**RE: 400 Carlton Avenue**

I reviewed the drawings, evaluated the site context, and prepared a review letter for a similar project design in 2017. My comments and recommendations are as follows:

CURRENTLY PROPOSED SITE PLAN

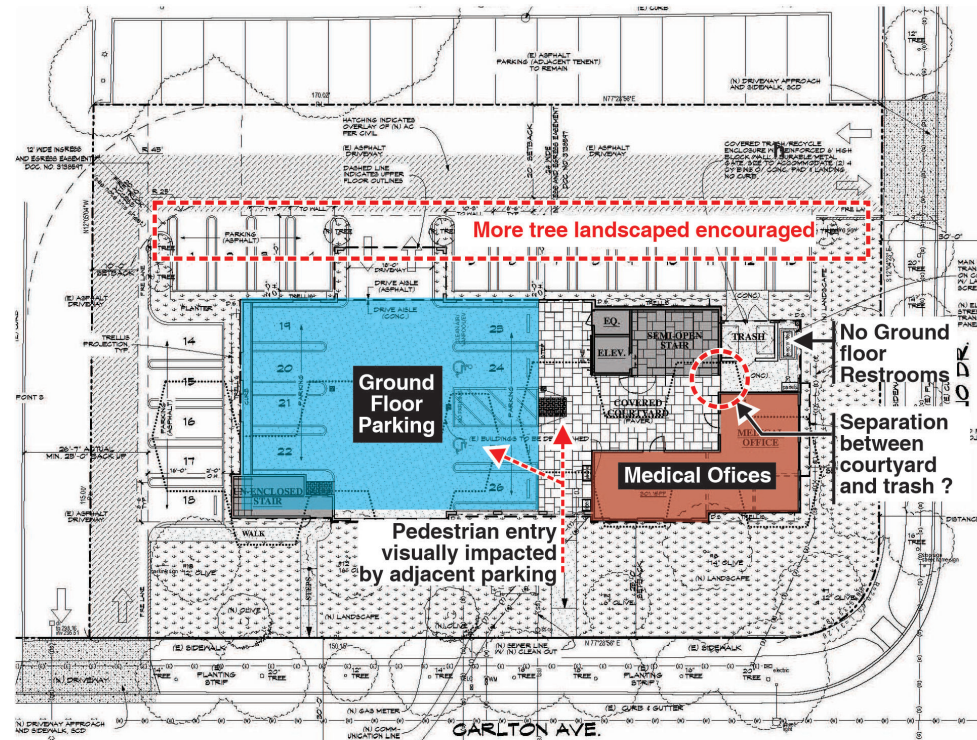
The project has been redesigned to eliminate the underground parking and to move it within the framework of the building's first floor envelope- see site plan and first floor comparison diagrams below. Notable features of this change include the following:

- Ground floor medical office space has been substantially reduced in area.
- Additional building mass has been added to the interior side parking lot side of the structure and removed from the rear.
- The pedestrian entry experience has been changed.

**Streetscape: Same Side**

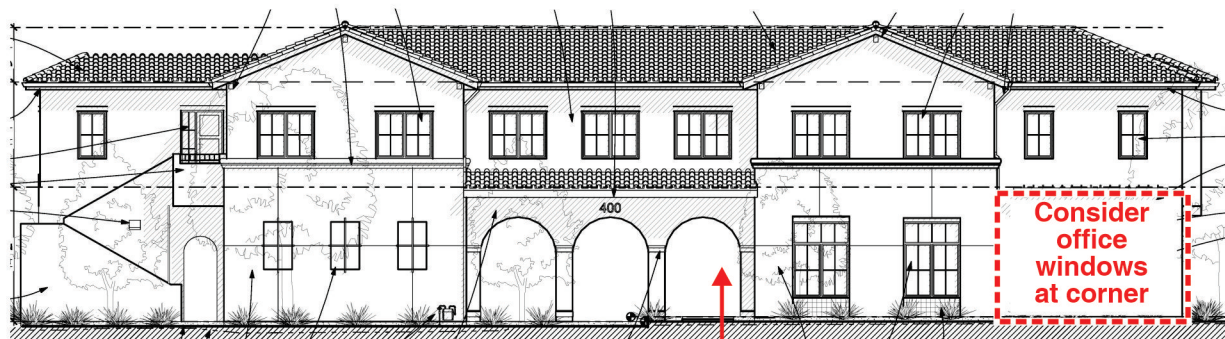
While the length of the structure facing Carlton Avenue has increased, the overall height of the building would remain the same as the approved design - see streetscape illustration below.

**CURRENTLY PROPOSED FRONT ELEVATION**

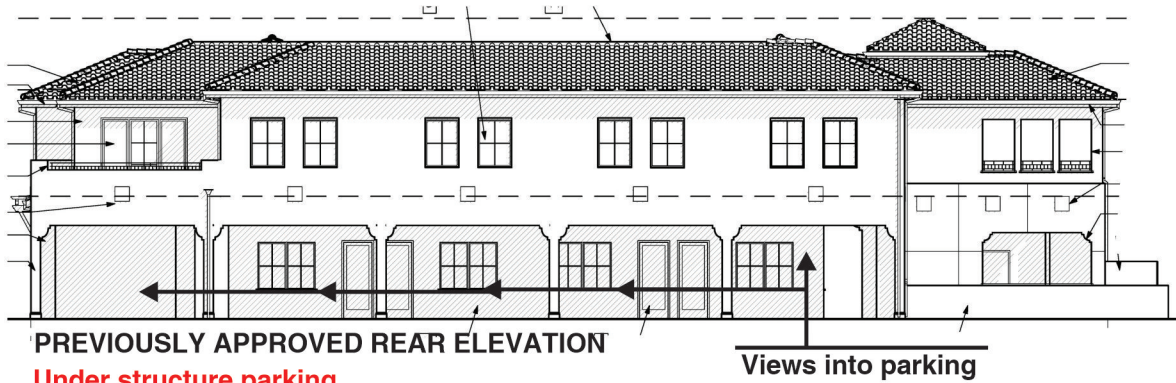
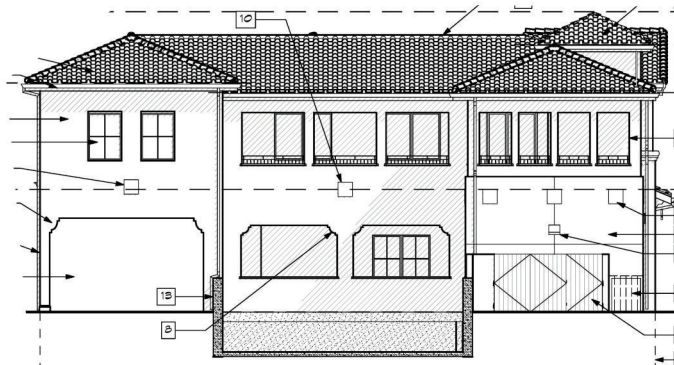
**Covered ground floor walkway created substantial facade depth**  
**Enclosed stairway and elevator to left is rather blank**

**Covered ground floor walkway creates substantial facade depth but view is to parking**  
**Street-facing gable forms are similar, but scale is bigger**  
**Articulated exterior stair to left is more visually interesting**  
**Smaller scale second floor windows**

**PREVIOUSLY APPROVED PARKING LOT SIDE ELEVATION**

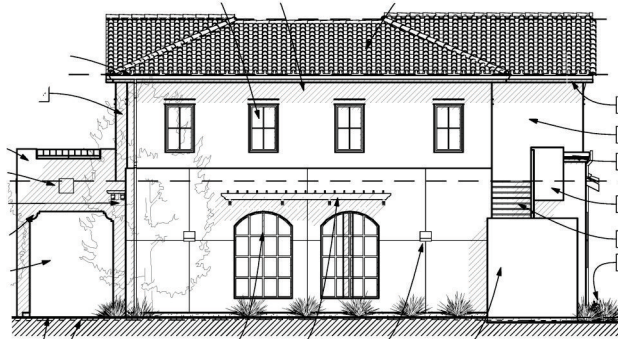
Ground floor largely auto and trash-oriented  
Second floor windows express corridor

Ground floor openings with decorative grills in lieu of windows  
Exterior stair adds articulation and visual interest  
Second floor windows express offices
